**TOSHIBA CONSUMER PRODUCTS, INC.**

**TECHNICAL BULLETIN**

No. VCR9501A

**Subject:** Power supply switching interference.**Ref. #:** 10A-9402**Symptom:** TV picks up power supply switching interference from VCR.**Required part(s):**

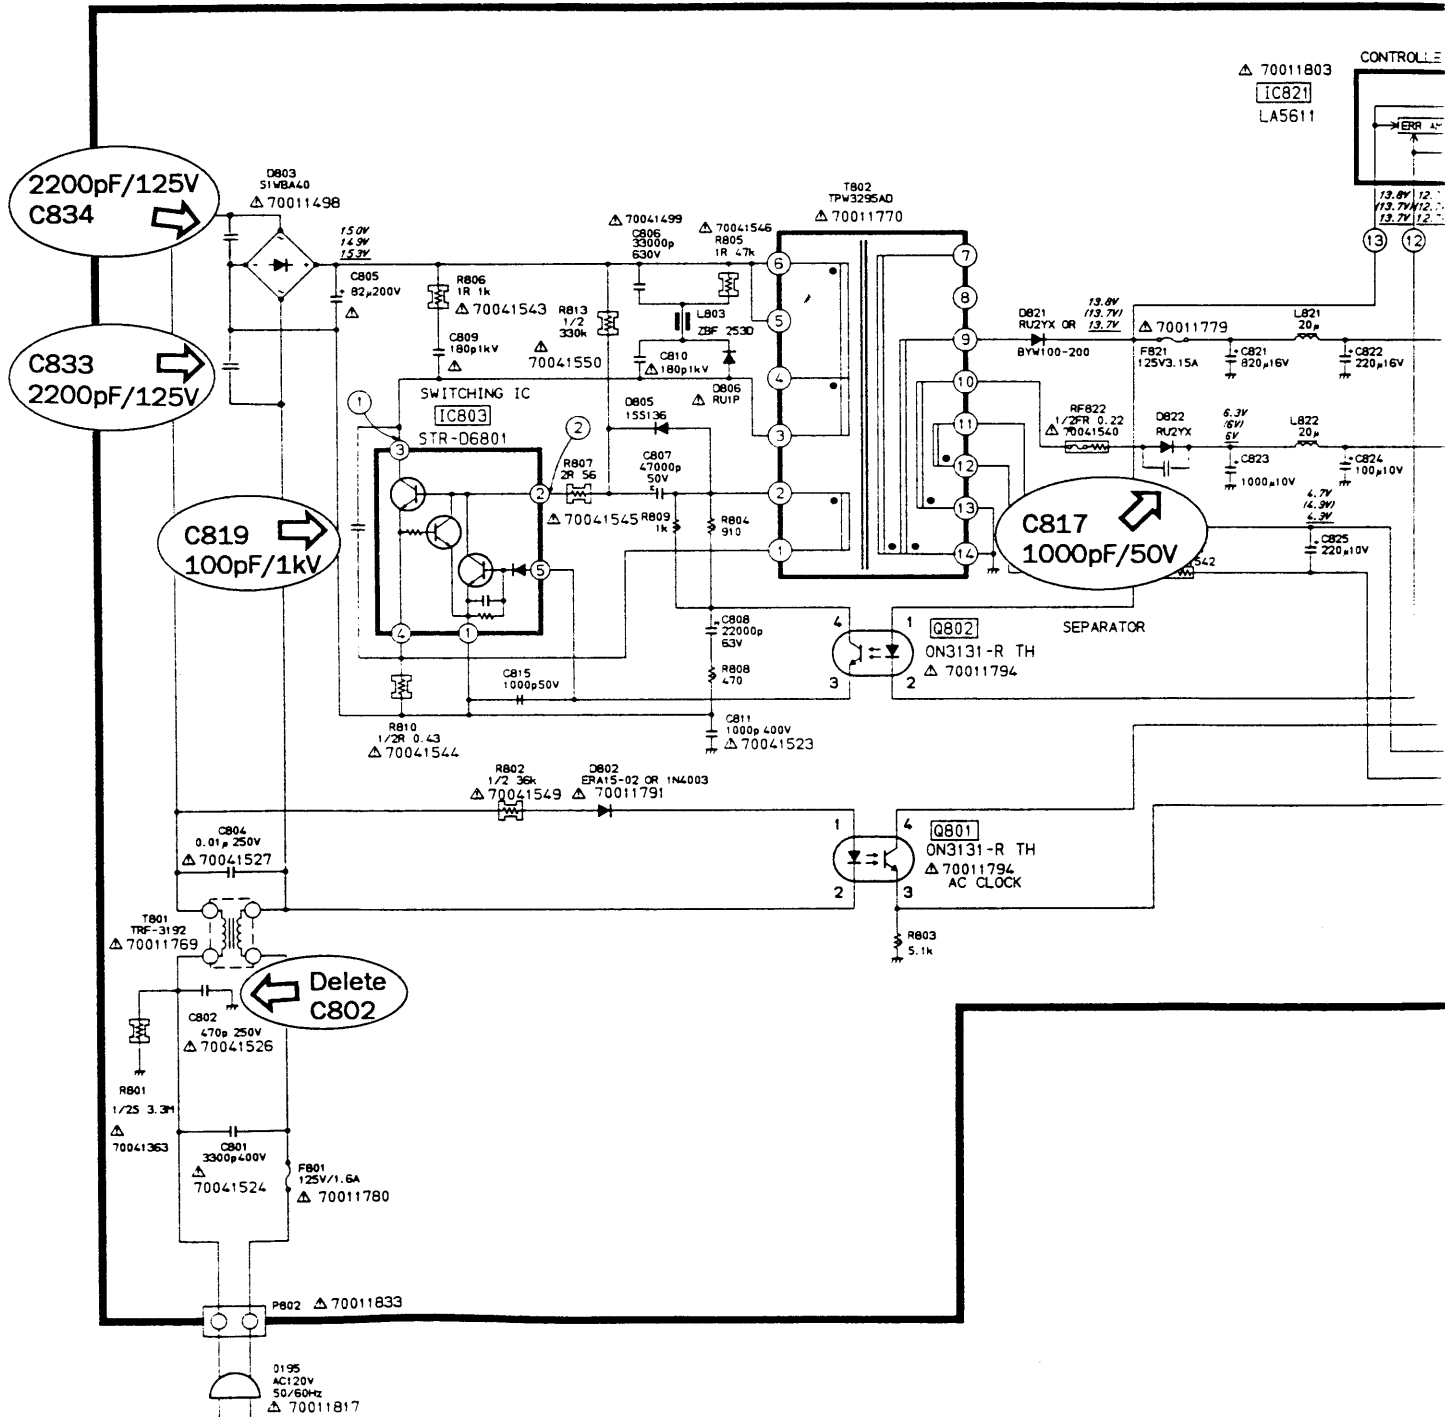
**Corrective Action:** 1) Remove capacitor C802.

2) Add 4 Capacitors, from 70903925 capacitor kit above, to the foil side of Main PC board, as shown in the illustrations on the attached sheet or these the following verbal instructions: Add C817 across D822, add C819 across pins 3 and 4 of IC803, add C833 from + AC side of D803 to the -DC side of D803 and add C833 from the -DC side of D803 to the -AC side of D803.
